# CITY COUNCIL MEETING

**Subject:** West Point Dairy Products, Receiving and Warehouse Expansion – Seeking site plan approval from the City Council for receiving and warehouse expansion located at 570 North 500 West.

**STAFF COMMENTS – Fourth Review**

See Sheet T1.1PHA

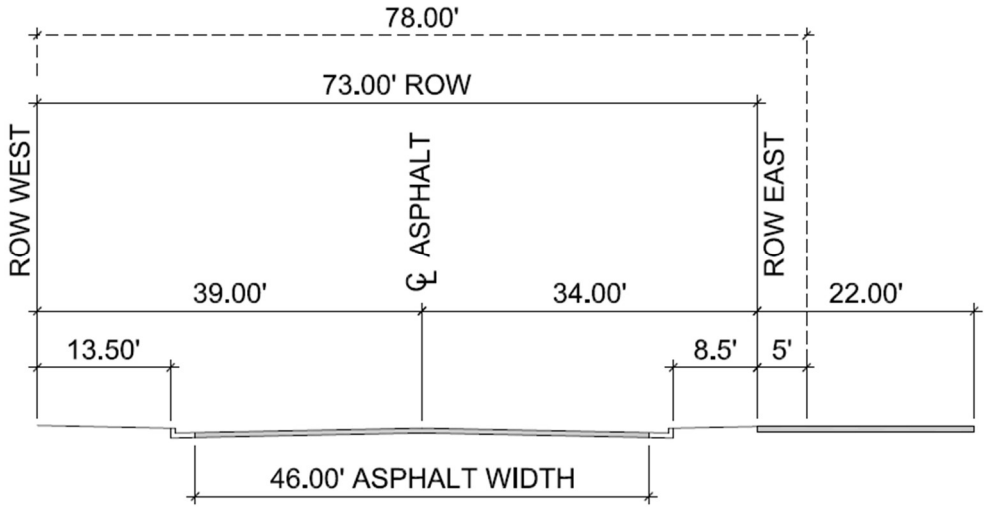
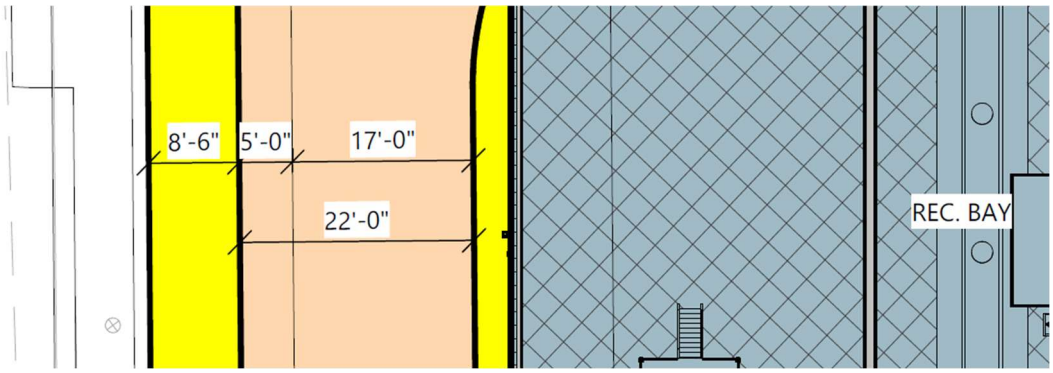
1. In a collaborative effort between Hyrum City and WPD for WPD to comply with HCC 17.49.080, staff is recommending the Planning Commission and City Council approve the following right-of-way width reductions abutting the WPD project:
    a. 500 West right-of-way be reduced from 78.00’ feet to 71.00’ feet; and

b. 700 North right-of-way be reduced from 78 feet to 73 feet.

(13.50’ park strip reduced to 8.5’)

SHEET NUMBER
**C1.3B**

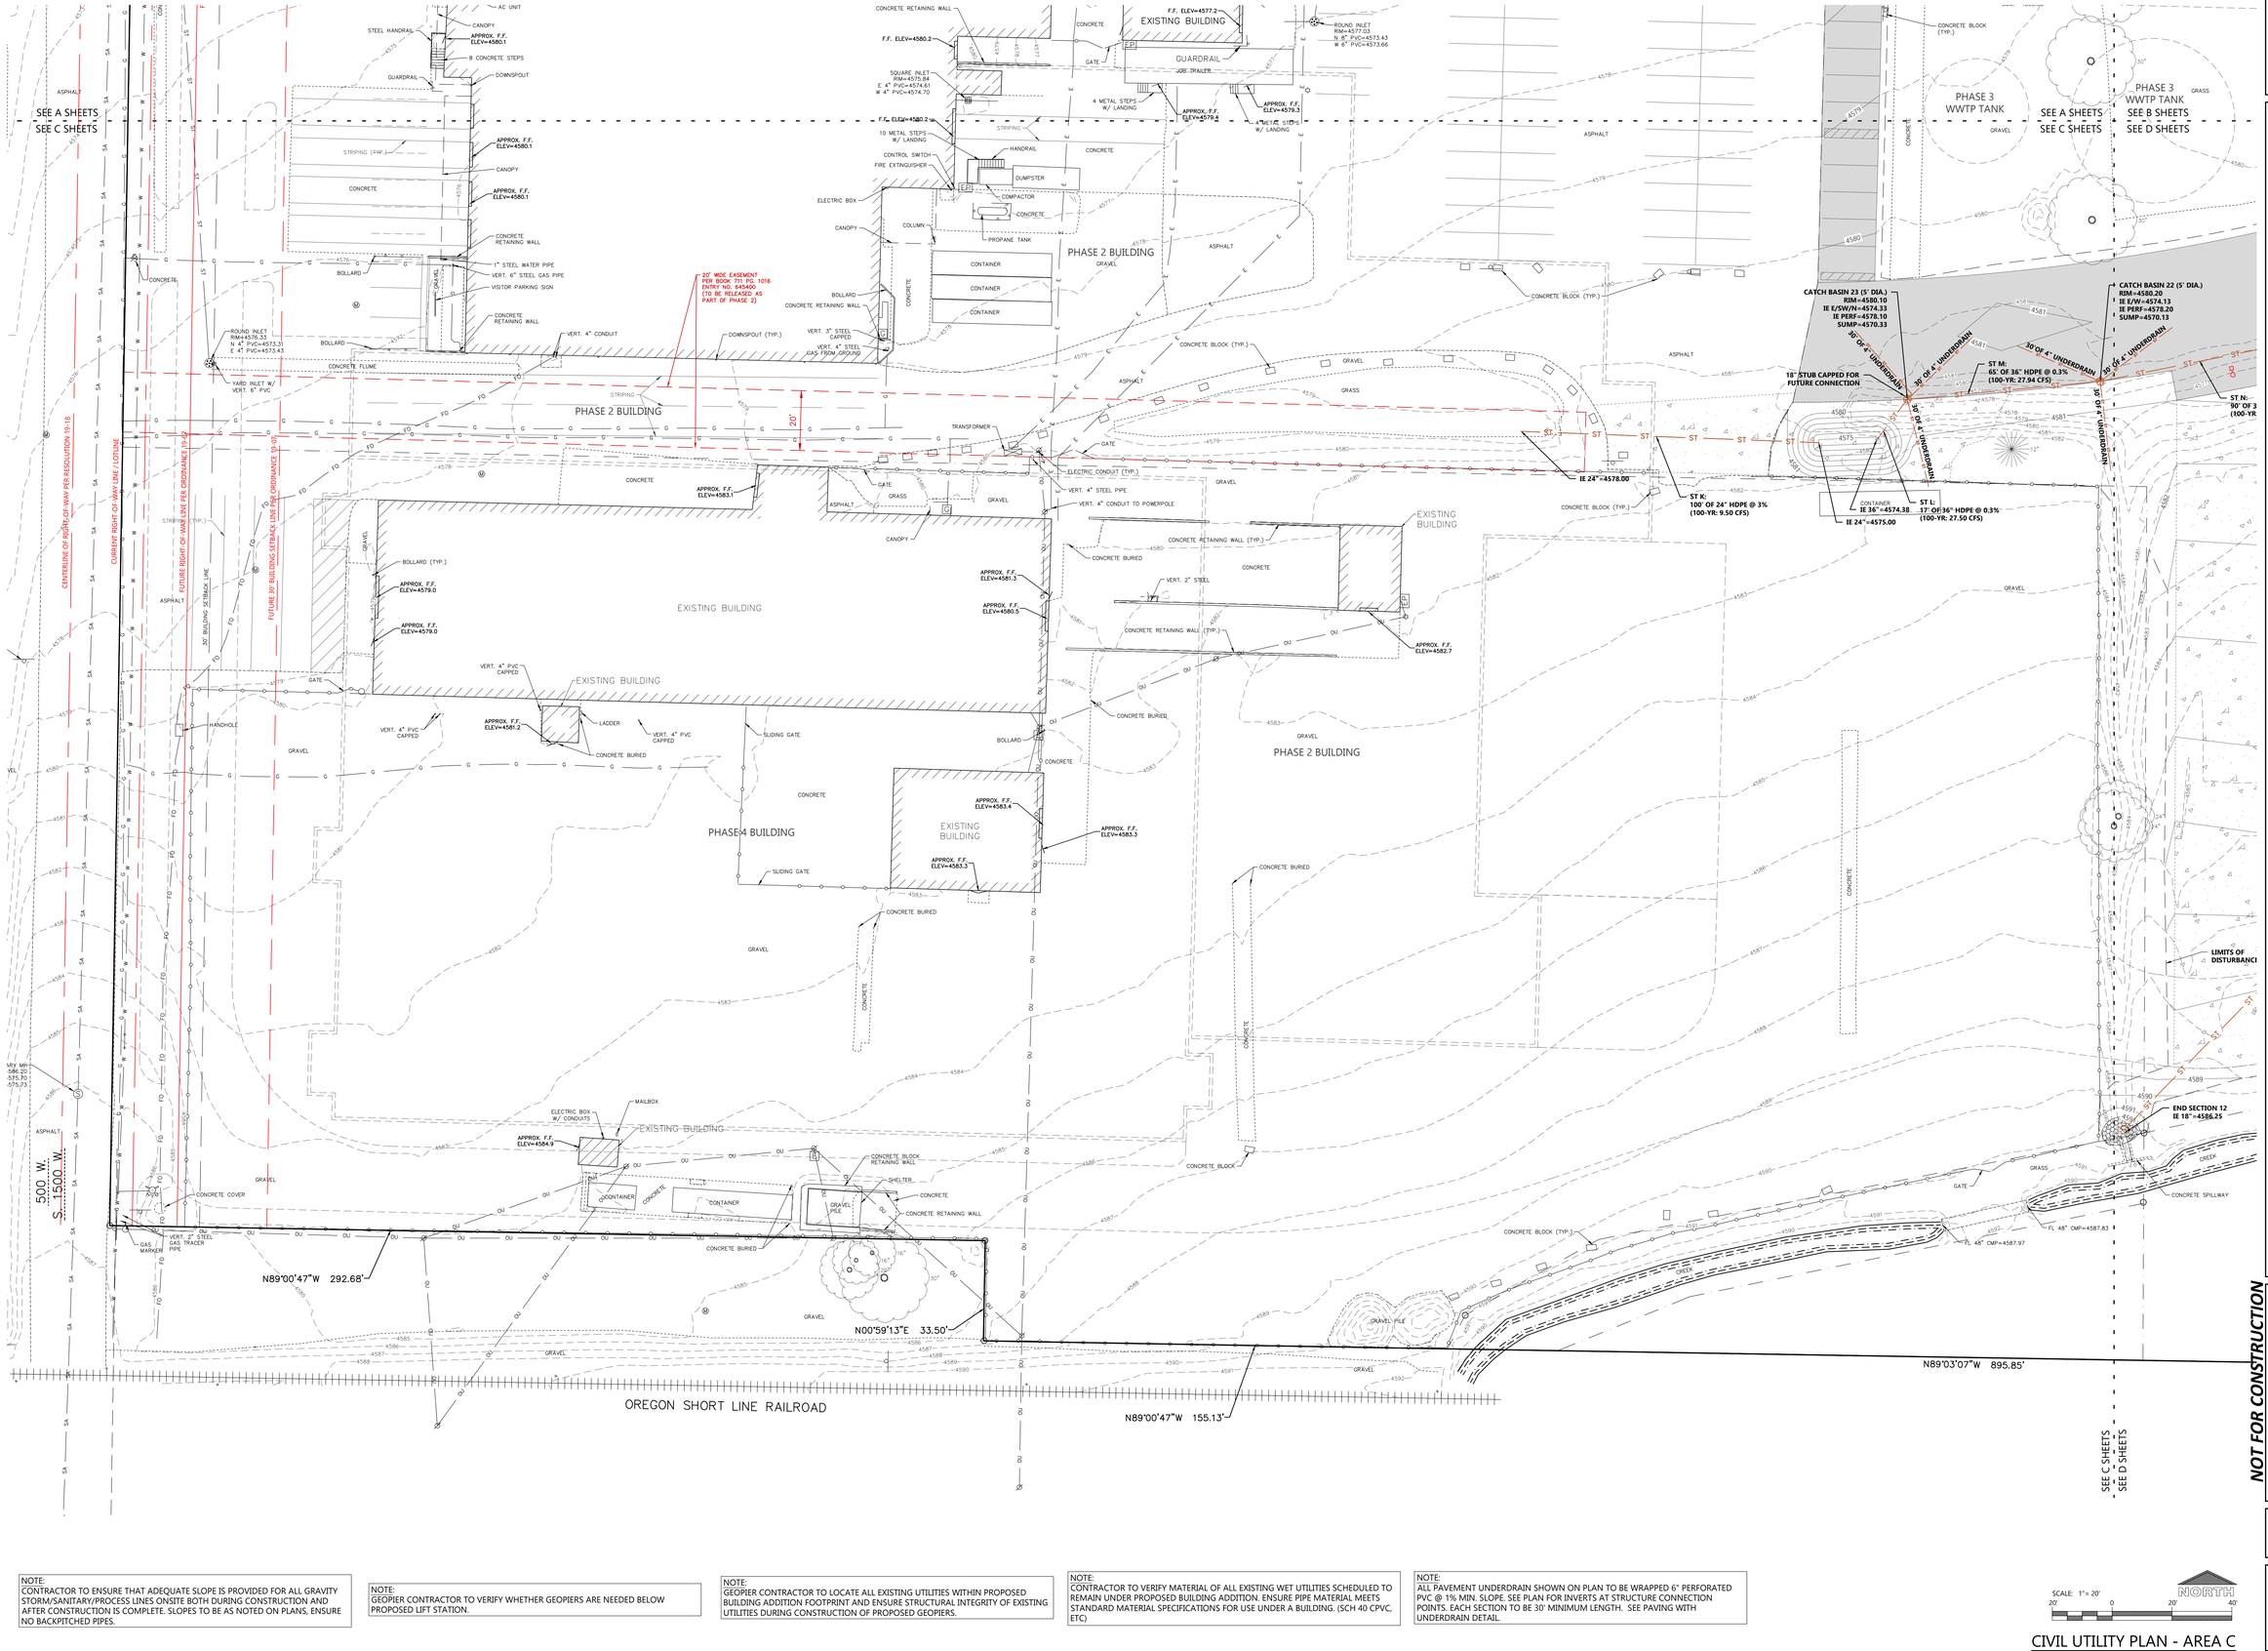
5. On Sheet C1.3A it is unclear if the sanitary line per civil utility plan project #1912060 is currently in use or capped. See comment #3.
   *Excel Response: References to capped lines have been changed to better indicate items are cleanout cap locations.*

**Sewer Dept. Response 09/08/2026:** Resolved.
6. On Sheet C1.3A there is an approximate sanitary sewer line per Hansen Survey shown. Is this line ever in use. See comment #3.
   *Excel Response: The sanitary line in question is believed to be incorrect/non-existent and has been removed from the survey. Sanitary sewer and storm sewer lines have been adjusted to match what was existing/proposed as part of the 2019 WPD building addition.*

7. On Sheet C1.3A verify which existing sanitary sewer line or lines are in use that are directly connected to the sewer main. See comment #3.
   *Excel Response: Sanitary sewer lines and process sewer lines have been better differentiated by linetypes to match what is indicated in the legend on the cover sheet.*

8. On Sheet C1.3A confirm there are no sanitary sewer line connections to the sewer main in 500 West.
   *Excel Response: There are believed to be no connections to the sanitary sewer main in 500 West from the main WPD facility. The existing buildings on Parcel 03-060-0084 likely have a sewer connection to 500 West. That sanitary lateral will be removed/capped at the lotline when the existing buildings are razed as part of a future phase of construction.*
   Sewer Dept. Response: Per Bill Steffens, there is a WPD sanitary sewer connection on 500 West. The connection needs to be shown on the drawings.

9. On Sheet C1.3A there is a 20,000 gallon lift station shown. What is the detailed function of this lift station, and will it require secondary containment?
   *Excel Response: The proposed lift station shown captures the wastewater discharge from the process drain system and is used to pump that discharge to the on-site pre-treatment facility.*
   Sewer Dept. Response: Will the lift station be on back up power? Is there pump redundancy?

2. On sheet C1.3A of the construction drawings, it shows a new sewer lateral tying onto the City's 4600 south sewer trunk line. Is this planning to be installed before or after the new road is built?
   *Excel Response: West Point will work with contracting partners to have this connection made prior to road construction if possible. Primary objective will be to at a minimum make the connection and extend the line to the West Point site for connection during the other construction activities.*

3. On sheet C1.3A a new 8" fireline is called out. Is this replacing the existing fireline on 500 West, or adding to it? Please call out the already existing fireline and verify. Hyrum City would like to know how many total fire lines will exist at total buildout.
   *Excel Response: This fire line will replace one of the existing fire lines serving the building. This new line feeds into the proposed addition and provides coverage for the new Cream Receiving and Churn Room areas of the project in addition to back feeding the existing risers and providing coverage of areas north of the existing cooler & freezer within the existing building.*

SHEET NUMBER
C3.1

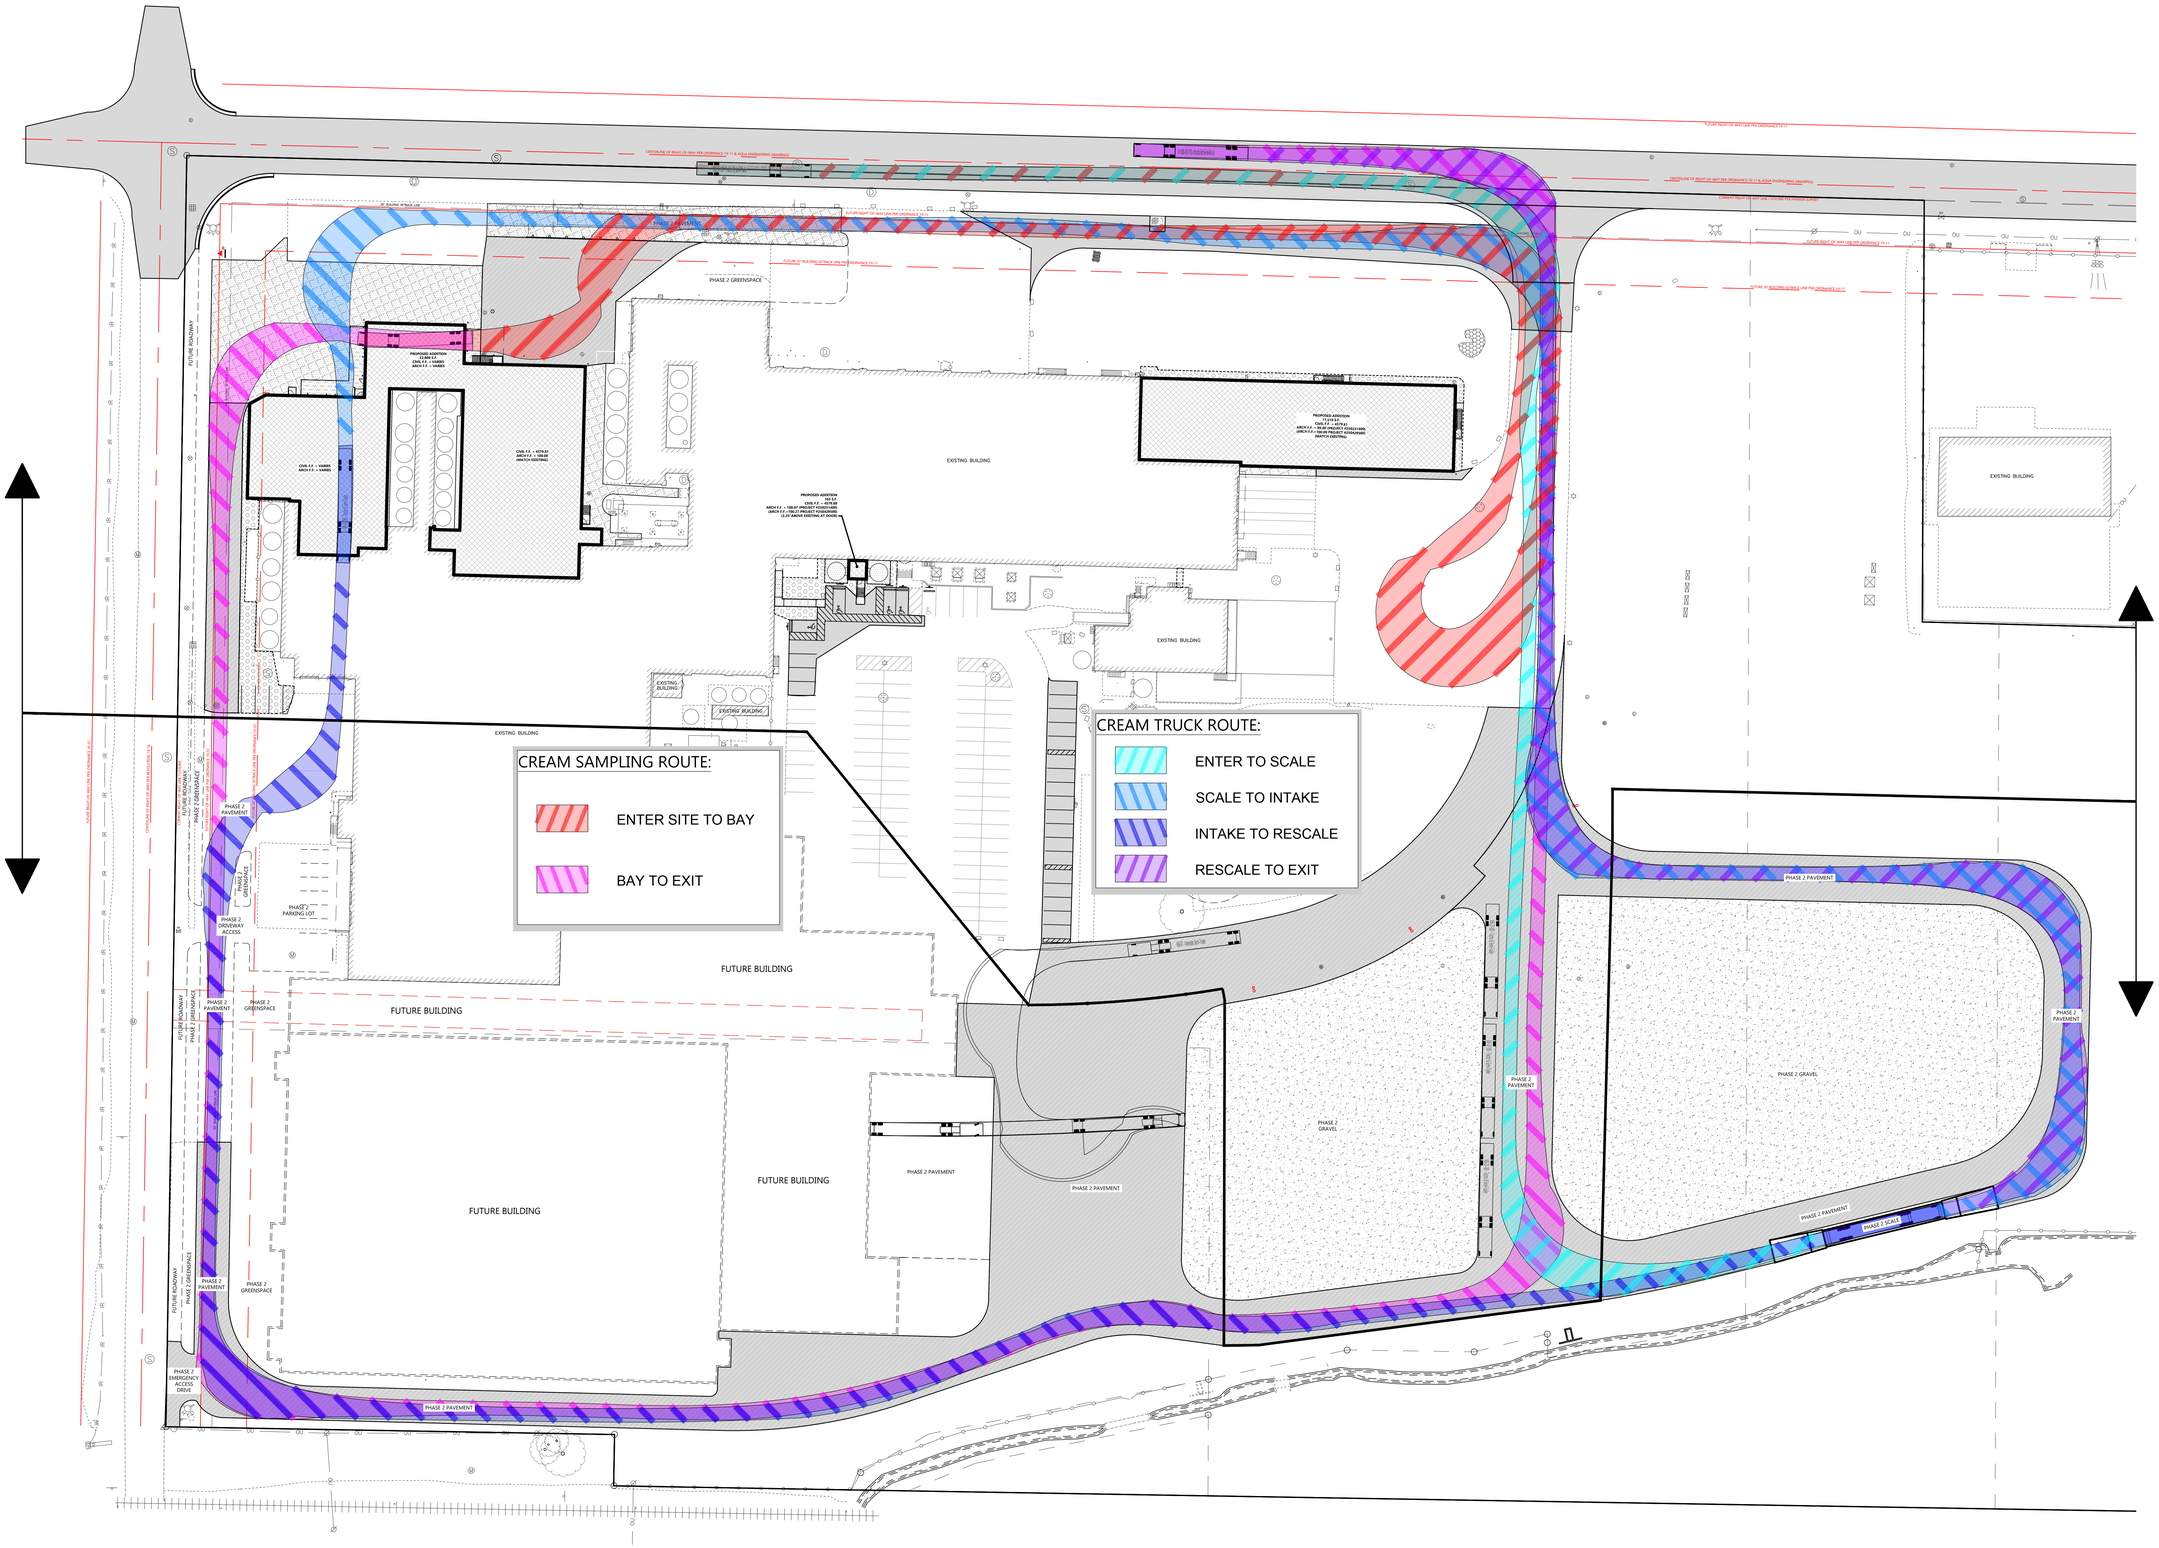
2. HCC 17.49.020 Use Regulations: Food processing/mills is a permitted use in the M-2 Zone.
*Excel Response: Understood*
3. HCC 17.49.022 Lighting Plan: Sheet C3.1 Civil Site Photometric Plan has been provided for new lighting for the expansion. The lamps in the schedule identify the lamps are to be tilted. Applicant shall verify and comply to this section requiring that all new lighting shall prevent glare onto properties and shall be dark-sky sensitive.
*Excel Response: There are no new poles being added as part of this first phase of expansion. Three existing poles are moving slightly to allow for widening of the driveway. The existing poles and light fixtures will be reinstalled at the new locations. Heads will be pointed toward the facility and use cut off fixtures. Maximum light pole height will match existing installation. A light pole detail has been added to Sheet C3.1.*

Staff Response: Resolved. The detail provided following the June 16, 2026 discussion is not the detail staff requested. Staff requested specification sheets for each light fixture as Excell provided on Sheet PXP2 of the North Expansion through as separate site plan approval application.
